Addendum 36: Regulation No. 37

Revision 2 - Amendment 5

UNIFORM PROVISIONS CONCERNING THE APPROVAL OF FILAMENT LAMPS FOR USE IN APPROVED LAMP UNITS OF POWER-DRIVEN VEHICLES AND OF THEIR TRAILERS

CATEGORY PY21W Sheet PY21W/1

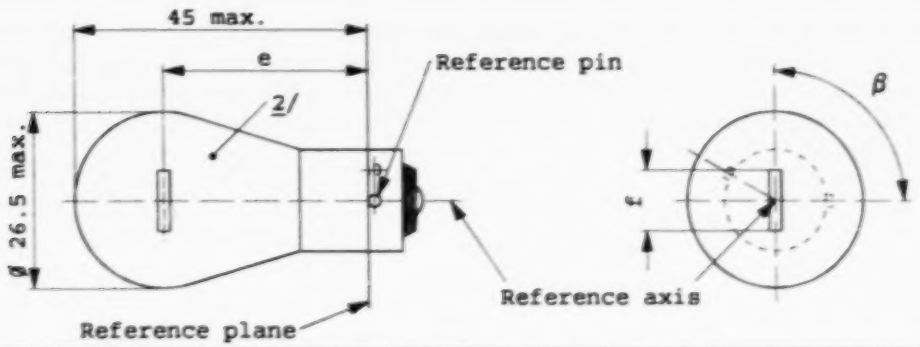
Sheets PY21W/1 to PY21W/3 (existing), replace by the new sheets PY21W/1 and PY21W/2, to read (see below):

DIMENSIONS in mm	Filament lamps of normal production			Standard filament lamp
	min.	nom.	max.	
e		31.8 3/		31.8 ± 0.3
f 4/			7.0	7.0 $^{+0}_{-2}$
Lateral deviation 1/		3/		0.3 max.
β	75°	90°	105°	90° ± 5°
Cap BAU15s in accordance with IEC Publ. 61 (sheet 7004-19-1)				
ELECTRICAL AND PHOTOMETRIC CHARACTERISTICS				
Rated values	V	12	24	12
	W	21		21
Test voltage	V	13.5	28.0	
Objective values — Watts	W	26.5 max.	29.7 max.	26.5 max at 13.5V
Objective values — Luminous flux	lm	280		
	±%	20		
Reference luminous flux :	Amber bulb: 280 lm Clear bulb: 460 lm	at approx. 13.5 V

CATEGORY H3 Sheet H3/1

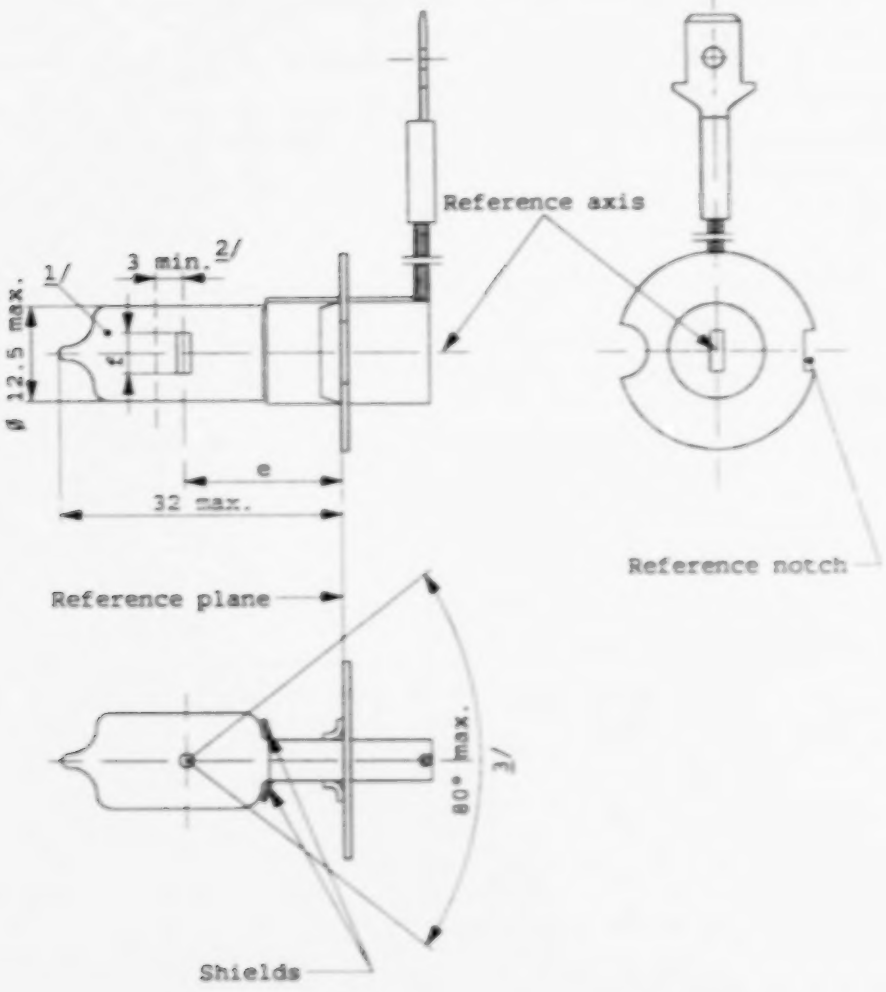
Sheets H3/1 to H3/6 (existing), replace by the new sheets H3/1 to H3/4, to read (see below):

CATEGORY H11 Sheet H11/1

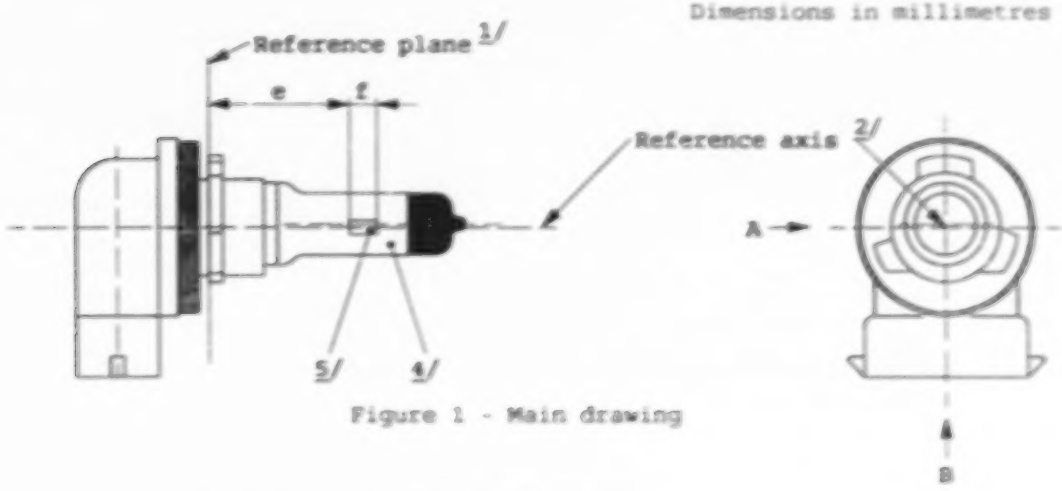
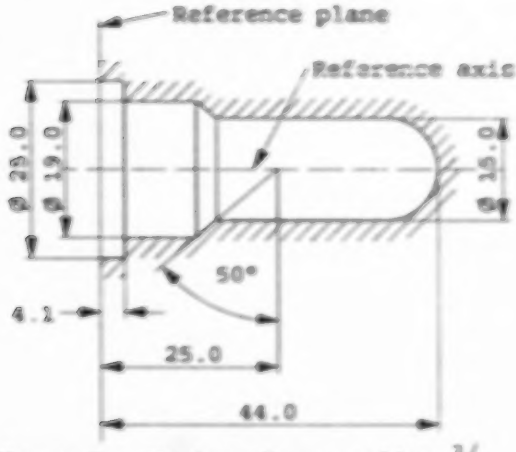
Add at the end new sheets H11/1 to H11/4, H12/1 to H12/3 and WY21W/1 to WY21W/2, to read (see below):
